Title: Advisory Committee on Reactor Safeguards
 NuScale Design-Centered Subcommittee
 Open Session

Date: Wednesday, February 15, 2023

SUBJECT: NuScale Power, LLC Submittal of Presentation Materials Entitled "US460 Design and SDAA Overview Update," PM-135236, Revision 0 (Open Session)

US460 Design and SDAA Overview Update

RXB Design Changes

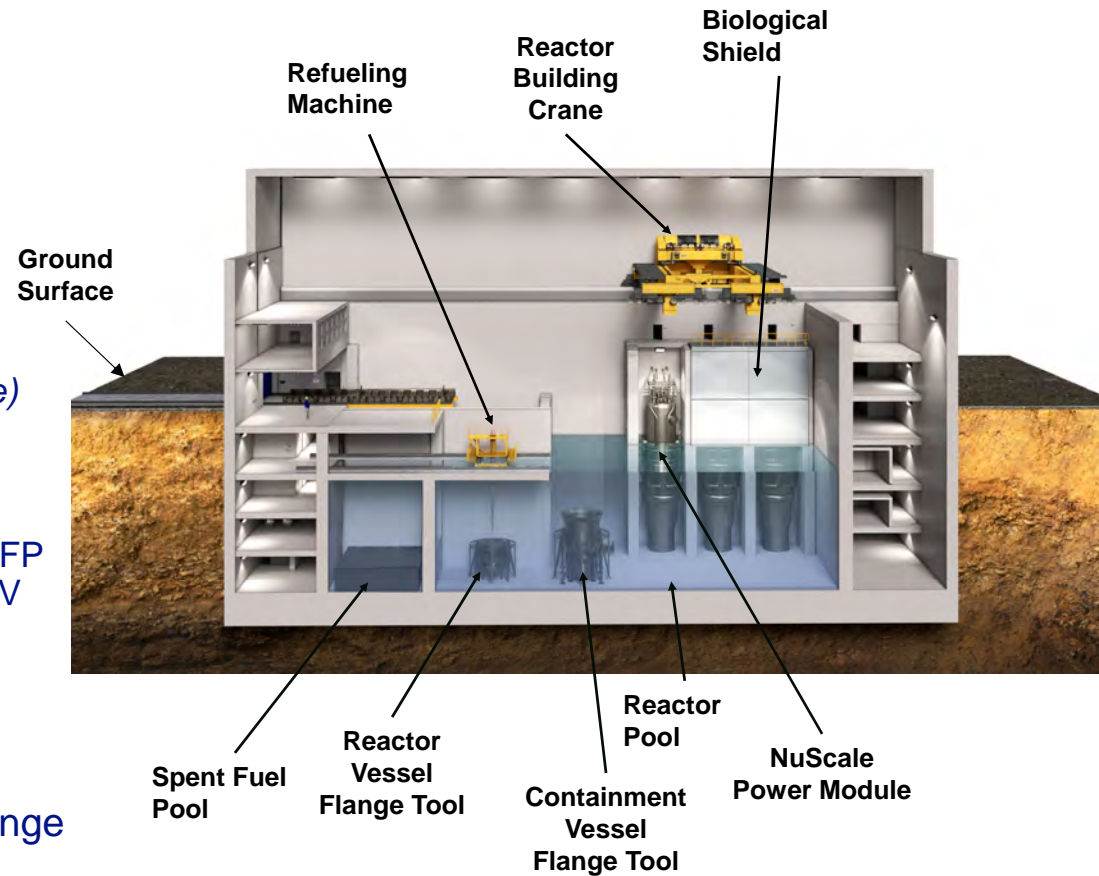
1 MEMBER PETTI: Just a question for
2 clarification. So the bioshield is actually deeper
3 than it was in the previous design.

11 MEMBER BROWN: Could I ask a question?
12 Charlie Brown.

14 MEMBER BROWN: Is the water level now
15 lower in the reactor pool building now that -- I'm
16 trying to remember whether it covered upper, closer up
17 to the top of the head or not.

20 MEMBER BROWN: Thank you. So you're
21 really using the bioshield then to pick up that
22 change, from a radiation standpoint?

4 MR. CUMMINGS: That is -- it's, yeah,
5 deeper, longer. There's you know --

7 MR. CUMMINGS: So that point where it
8 shows bio, biological shield, there was one panel, and
9 now there's two.

18 MR. CUMMINGS: Yes, it did. So that the
19 reactor pool level was reduced by about 18, 19 feet.

23 MR. CUMMINGS: To ensure that we have a
24 similar level of radiation protection and dose rates
25 in the reactor building, yes, we want -- we did not

1 want to have a streaming path, you know, between the
2 water and, you know, not having a bioshield there. So
3 yes, that's for radiological protection.
